CROSSWALK ILLUMINATION

CITY OF SANTA CLARA

June 15, 2020

AGNEW ROAD AND LAFAYETTE AVENUE (FIRST REVIEW)

PEDESTRIAN SIGNAL HEAD TIMING ACROSS LAFAYETTE AVENUE:

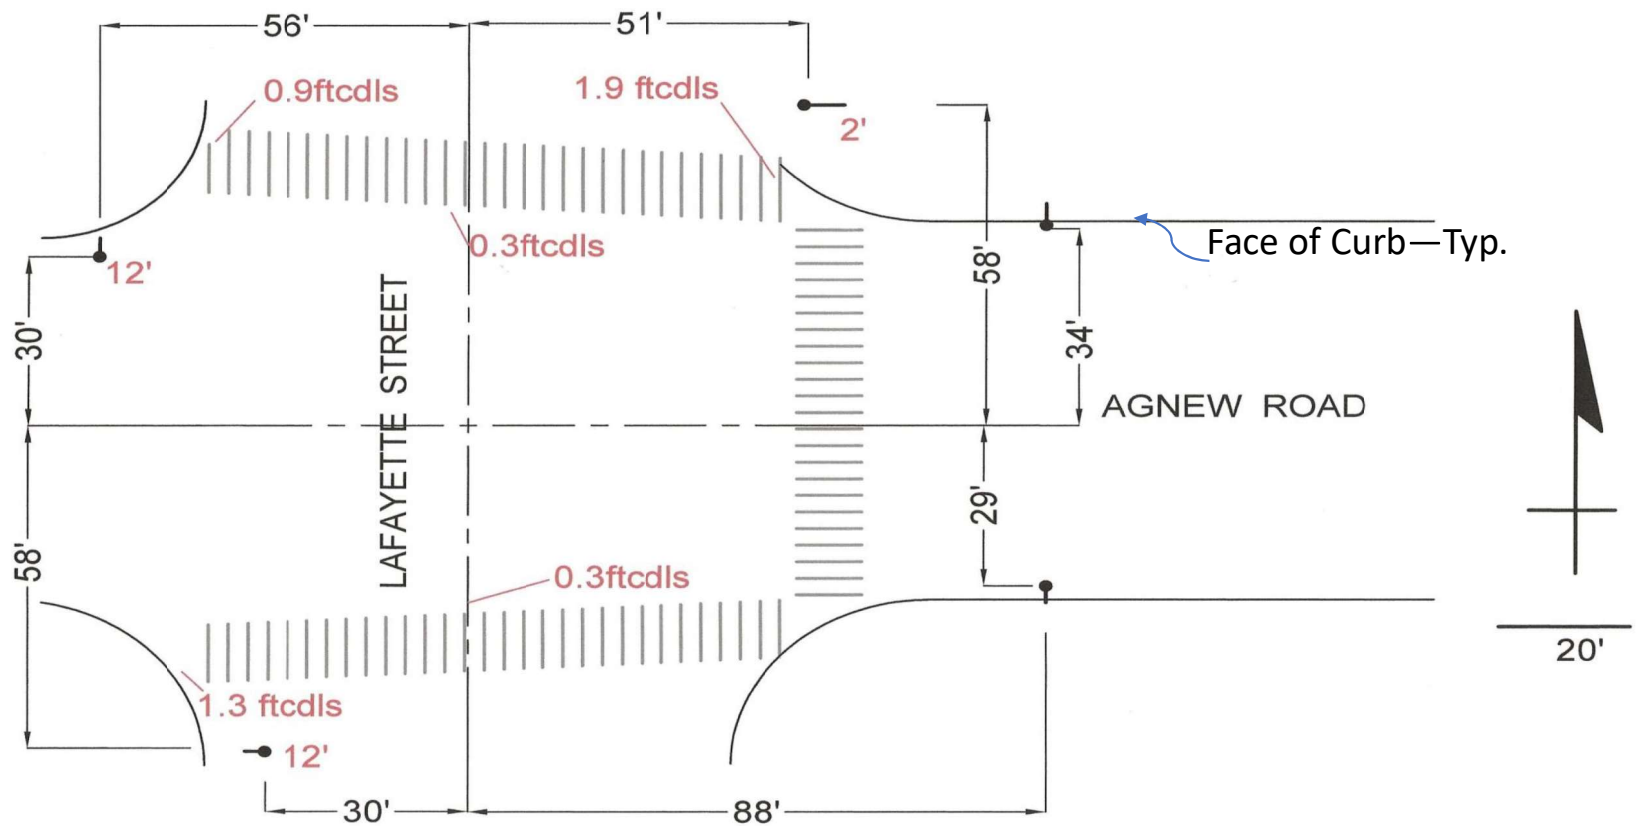
- a. Green Vehicle Signal Light for Agnew Road
- b. Lafayette Avenue is 80' wide

PLOT OF EXISTING POLE LOCATIONS AND ARM LENGTHS AND ILLUMINATION LEVELS

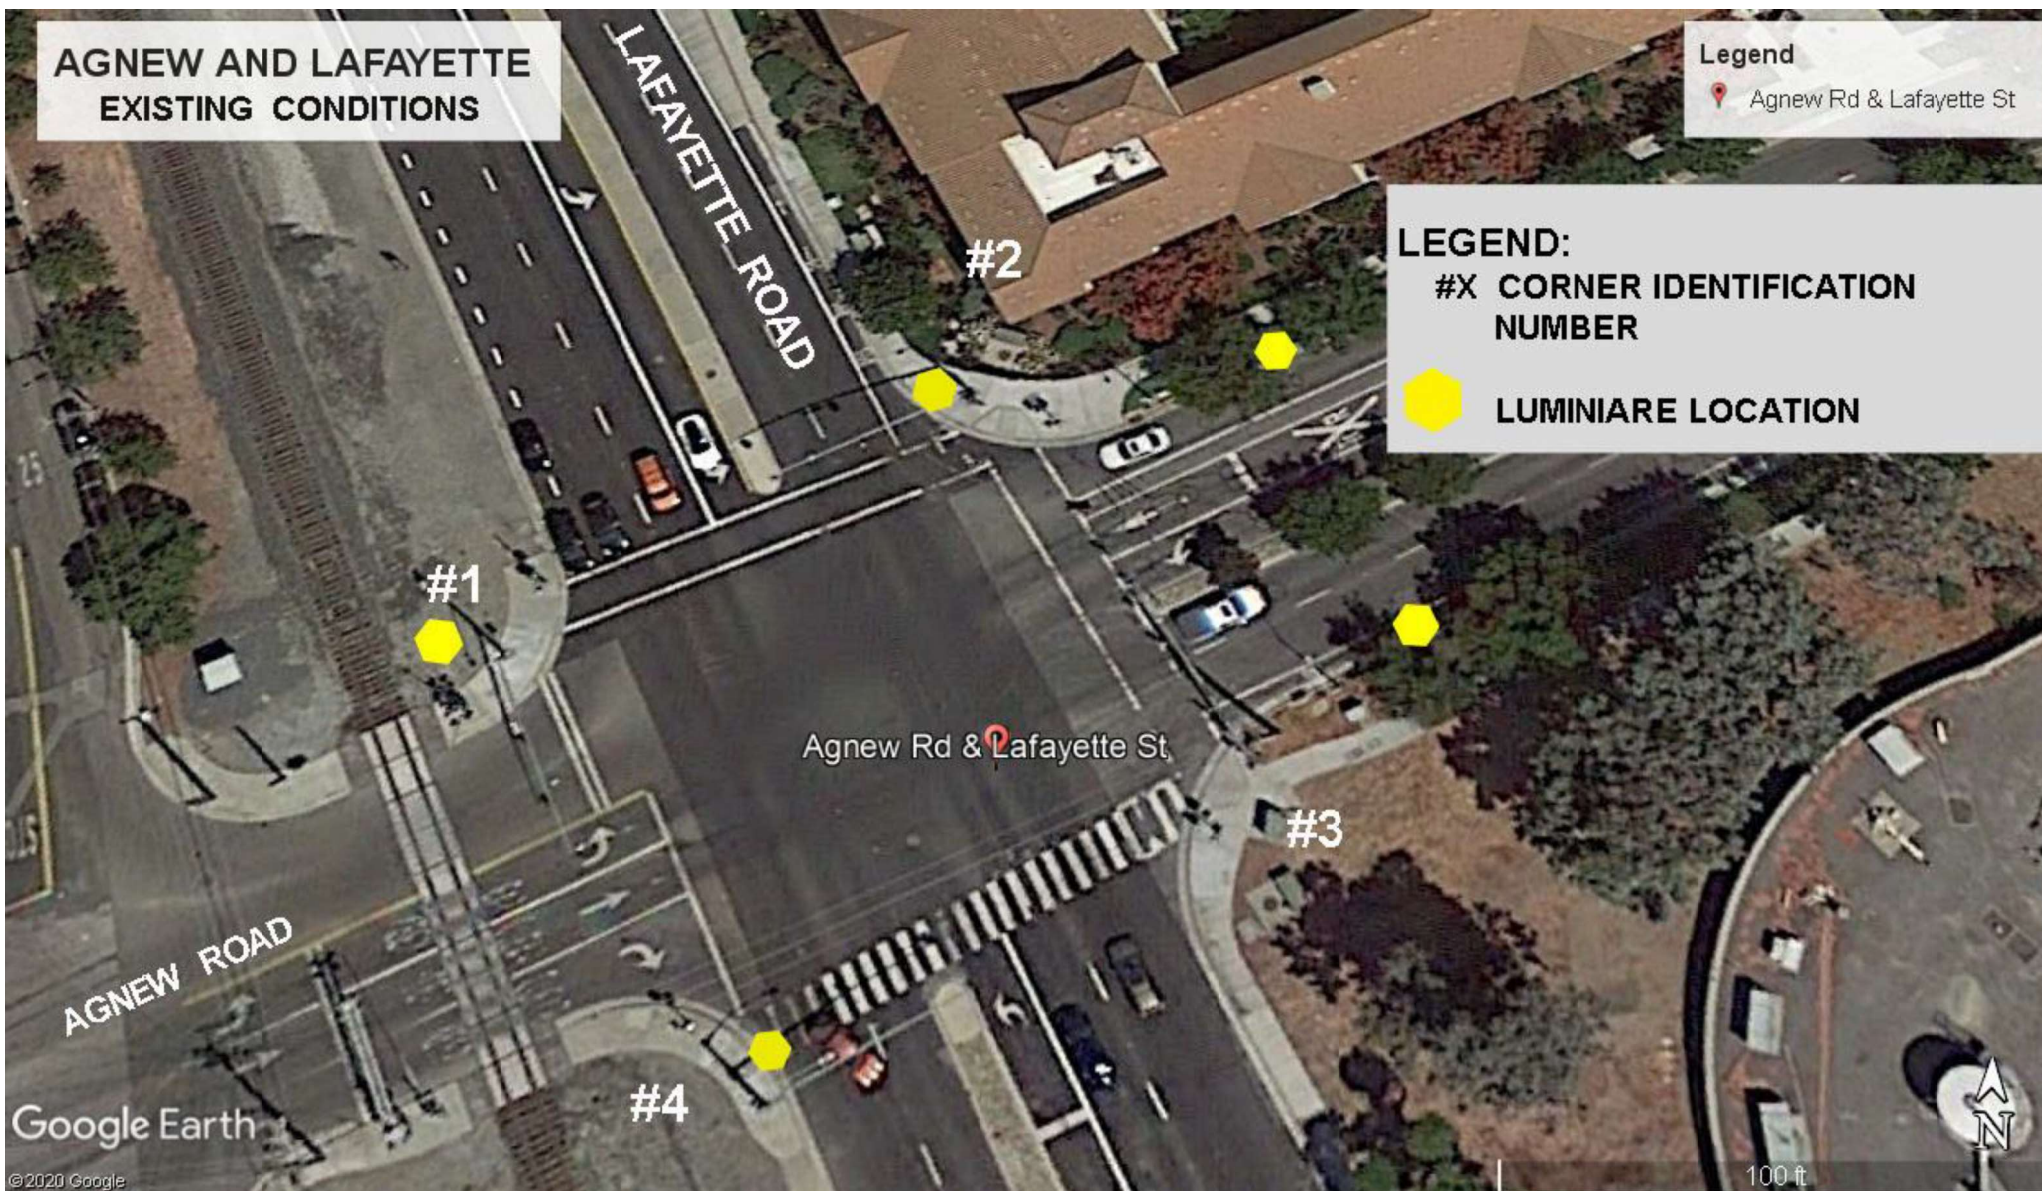
EXISTING POLE IS TALL WITHOUT A CROSSWALK LUMINAIRE. EXISTING ILLUMINATION IS 0.9 ftcfs AT THE LIP OF GUTTER.

THERE IS NO CROSSWALK FOR CROSSING AGNEW ROAD. THE EXISTING LUMINAIRE'S RATING IS TOO LOW.

ILLUMINATION AT THE LIP GUTTER IS 1.9 ftcfs. THE EXISTING LUMINAIRE'S ARM IS ONLY A FEW FEET LONG.

THE EXISTING POLE IS TOO SHORT AND LACKS A LUMINAIRE.

IT IS NOT VERTICAL, AND THE LUMINAIRE'S ARM IS TOO SHORT FOR ILLUMINATING THE CROSSWALK.

THE POLE HAS AN EXISTING LED LUMINAIRE THAT HAS A RATING WHICH IS TOO LOW.

IT HAS A MISSING LUMINAIRE ARM AND LUMINAIRE.

IT DOES NOT HAVE A LUMINAIRE - 0.3ftcdls.

THE POLE HAS AN EXISTING LED LUMINAIRE THAT HAS AN OUTPUT 1.3 ftcdls WHICH IS TOO LOW.

IT DOES NOT HAVE A LUMINAIRE ARM AND FIXTURE.

THE ILLUMINATION AT THE CENTER OF LAFAYETTE AVENUE AT EACH OF THE CROSSWALKS ALONG AGNEW ROAD IS 0.3ftcdls. THIS ILLUMINATION LEVEL IS TOO LOW FOR SAFETY.

SOLUTION: INSTALL A TYPE 15TS POLE WITH A NEW FOUNDATION AND WITH A 10' LUMINAIRE ARM AND A 14,000 LUMEN (TYPE 4 MEDIUM) LED LUMINAIRE.

SOLUTION: INSTALL A CROSSWALK AND REPLACE THE EXISTING LED WITH A 14,000 LUMEN (TYPE 4 MEDIUM) LED.

SOLUTION: RELOCATE THE EXISTING TRAFFIC SIGNAL POLE AND INSTALL A 15' LUMINAIRE ARM AND REPLACE THE EXISTING LED LUMINAIRE WITH A 14,000 LUMEN (TYPE 4 MEDIUM) LED FIXTURE.

SOLUTION: REMOVE THE EXISTING POLE AND FOUNDATION AND INSTALL A NEW TYPE 15TS WITH A NEW FOUNDATION. PROVIDE A 15' LUMINAIRE ARM AND A 14,000 LUMEN (TYPE 4 MEDIUM) LED FIXTURE.

SOLUTION: INSTALL A 15' LUMINAIRE ARM AND REPLACE THE EXISTING LUMINAIRE WITH A 8,000 LUMEN (TYPE 2 LONG) LED FIXTURE AND ADJUST THE POLE.

SOLUTION: INSTALL A NEW LED LUMINAIRE WITH A RATING OF 8,000. LUMENS (TYPE 2 LONG).

SOLUTION: INSTALL A NEW 10' LUMINAIRE ARM AND INSTALL A NEW LED LUMINAIRE WHICH HAS A RATING OF 14,000 LUMENS (TYPE 4 MEDIUM).

SOLUTION: REMOVE THE EXISTING POLE AND INSTALL A NEW TYPE 15TS POLE WITH A FOUNDATION. A 10' LUMINAIRE ARM IS REQUIRED WITH A NEW LED LUMINAIRE WHICH HAS A RATING OF 14,000 LUMEN (TYPE 4 MEDIUM).

SOLUTION: REPLACE THE EXISTING LED LUMINAIRE WHICH HAS A RATING OF 14,000 LUMENS (TYPE 4 MEDIUM).

SOLUTION: REPLACE THE EXISTING POLE WITH A TRAFFIC SIGNAL POLE TYPE 15TS THAT HAS AN 10' LUMINAIRE ARM. INSTALL A LUMINAIRE THAT HAS A RATING OF 14,000 LUMENS (TYPE 4 MEDIUM). THE INSTALLATION OF A STRIPED CROSSWALK IS ALSO REQUIRED.

COMMENT:

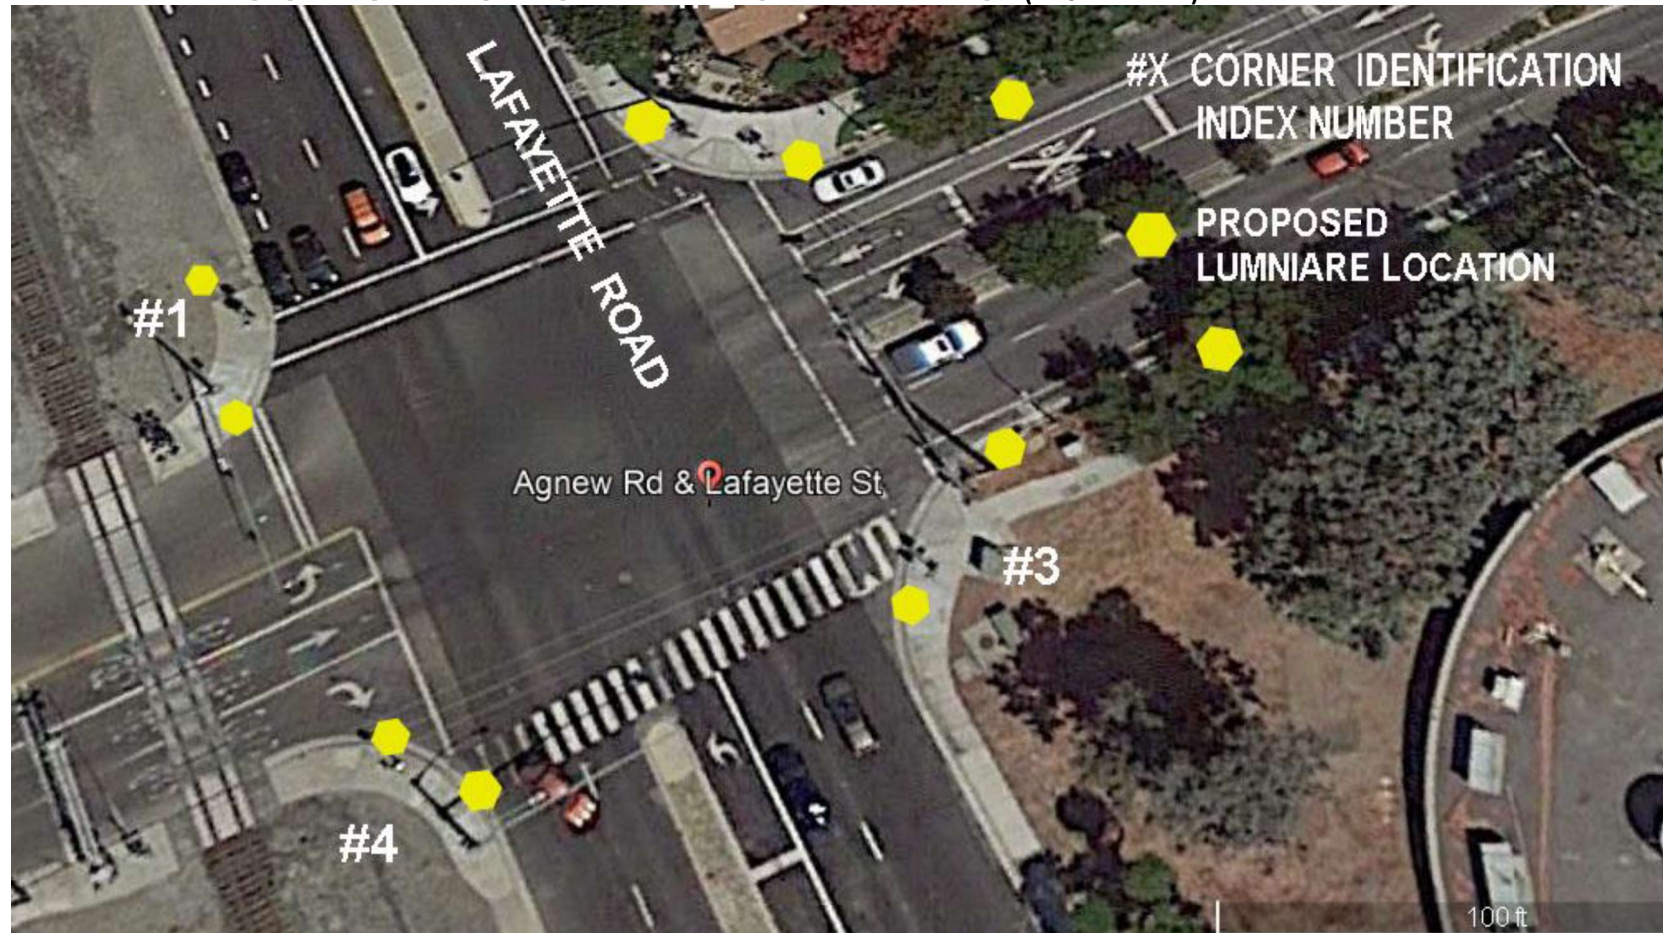
THE INSTALLATION OF STRIPED CROSSWALKS ACROSS THE STREET WEST OF LAFAYETTE AVENUE AND THE INSTALLATION OF ASSOCIATED STREET LIGHT POLES AND FOUNDATIONS ARE REQUIRED. 15' LUMINAIRE ARMS AND LUMINAIRES OF 8,000 TYPE 2 LONG LUMENS RATINGS ARE REQUIRED.

LAYOUT OF NEW POLES AND LUMINAIRE ARMS AND LUMINAIRES

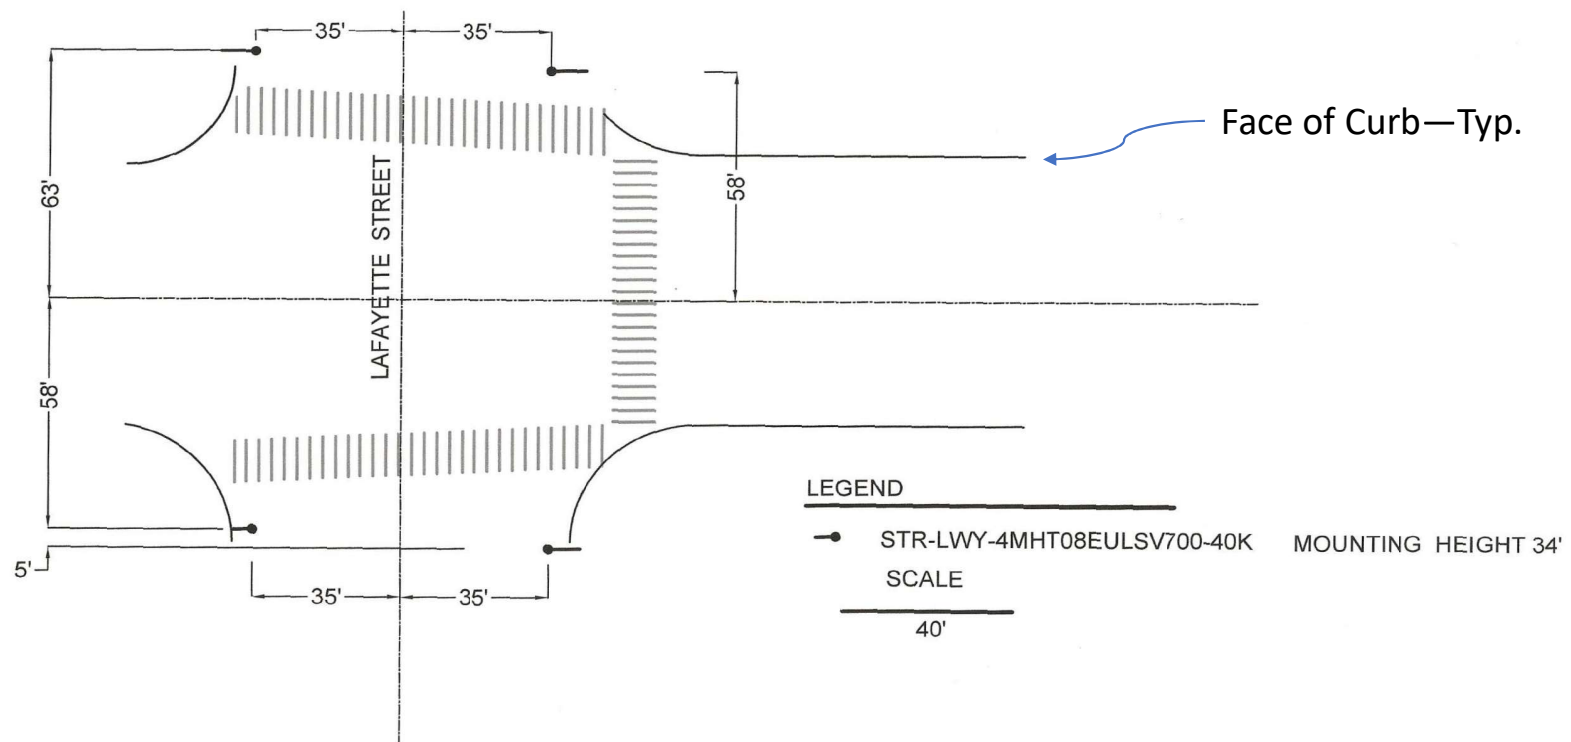
THIS REVIEW COVERS THE REDUCTION IN THE NUMBER OF ALTERNATIONS REQUIRED TO RAISE THE ILLUMINATION LEVELS TO ***IES RP-8-18 STANDARDS*** ONLY WITHIN THE CROSSWALKS ACROSS LAFAYETTE AVENUE. THE EXISTING POLES WHICH ARE NOT DEPICTED ON THE EXHIBIT ARE TO REMAIN UNALTERED.

THE EXISTING SIGNAL POLE FOR LAFAYETTE AVENUE IS TO BE REPLACED WITH A NEW TYPE 15TS POLE WITH A 10' LUMINAIRE ARM AND 15,000 LUMEN (TYPE 4 MEDIUM) LED FIXTURE.

THE EXISTING SIGNAL POLE LUMINAIRE ARM IS TO BE REPLACED WITH A 10' LUMINAIRE ARM AND A NEW LUMINAIRE FIXTURE WITH 15,000 LUMEN (TYPE 4 MEDIUM) RATING.

THE EXISTING SIGNAL POLE IS TO BE REPLACED WITH A TYPE TS15 POLE WITH FOUNDATION WITH A 15,000 LUMEN (TYPE 4 MEDIUM) FIXTURE AND A 10' LUMINAIRE ARM.

THE EXISTING SIGNAL POLE LUMINAIRE ARM IS TO BE REPLACED WITH A 10' LUMINAIRE ARM AND A 15,000 LUMEN (TYPE 4 MEDIUM) FIXTURE IS TO BE INSTALLED.
